## RESPONSE TO REQUEST FOR ADDITIONAL INFORMATION

### US-APWR Design Certification

Docket No. 52-021

**RAI NO.:** NO. 1062-7296 REVISION 4  
**SRP SECTION:** 03.08.03 – Concrete and Steel Internal Structures of Steel or Concrete Containments  
**APPLICATION SECTION:** 3.8.3  
**DATE OF RAI ISSUE:** 11/25/2013

**Figure 3.1-3 Conceptual Basemat Anchorage for SC Structure Wall**

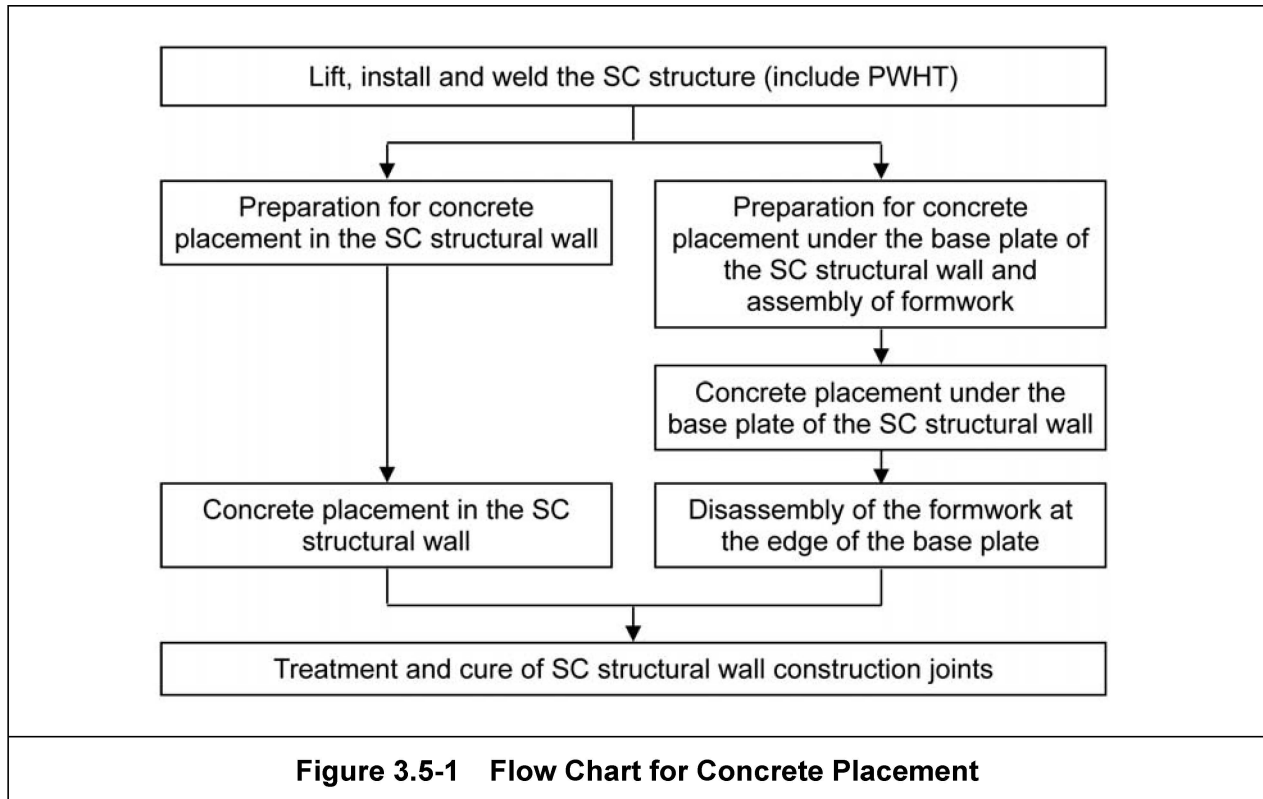
5. Correct the following inconsistencies in the report:
  - a. The stud layout shown in Figure 3.1-3, “Conceptual Basemat Anchorage for SC Structure Wall,” on Page 3-4, and the stud spacing/dimension and the use of the web plate/round tie bars shown in Figure 3.5-5, “Example of Concrete Placement in the SC Structure: General Section,” on Page 3-20 are inconsistent with the corresponding details shown in MUAP-11019-P, “Containment Internal Structure: Design Criteria for SC Walls,” Revision 1. This also applies to some other figures in the report which the applicant should confirm.

3. The "hold back" and tolerances established by the AWS D1.1 and AWS D1.6 weld program will dictate the vertical offset dimension tolerances for connection of the two ends of the tie bar and of fit-up tolerances of the faceplates of two adjacent SC module blocks.
4. The identified codes have been added to Technical Report MUAP-12006 Section 2.2 as requested.
- 5.a. Figures 3.1-3 and 3.5-5 have been revised to be consistent with Technical Report MUAP-11019 as requested. Also, Figure 3.5-8 through Figure 3.5-10, Figure 3.5-12
